MODIFICATION RECOMMENDED

N5241AS-02

N5241AS PNA Series Microwave Network Analyzers

Serial Numbers: ALL

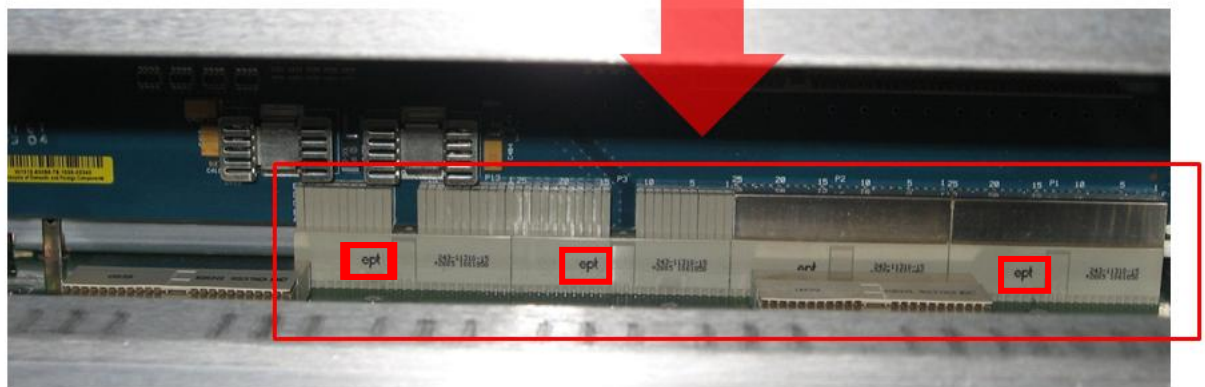
1. Remove the CPU assembly from the analyzer's rear panel. Refer to the PNA Service Guide chapter 7 section titled, "Removing and Replacing the CPU Board Assembly" for removal and reinstallation procedures. To view the online Service Guide, see the numbered list on the next page for instructions.
2. As per the photo below, inspect the system motherboard connector to see if it has one or more "ept" logos.

3. If the connector has one or more “ept” logos, return the analyzer to Agilent for replacement of the system motherboard. If the connector does not have one or more “ept” logos, email support_ctd-soco_support@agilent.com, providing the analyzer model and serial number and details of the malfunction symptoms.

4. *For Agilent Service Technicians only:* Only new boards without “ept” logos should be installed. Before installing the new board, look to see if it has one or more “ept” logos. If so, email support_ctd-soco_support@agilent.com, providing the analyzer model and serial number. Wait for further instructions in an email reply. New boards without “ept” logos can be installed.
For installation instructions, refer to the PNA Service Guide chapter 7 section titled, “Removing and Replacing the System Motherboard.” To view the online Service Guide, see the numbered list on the next page for instructions.
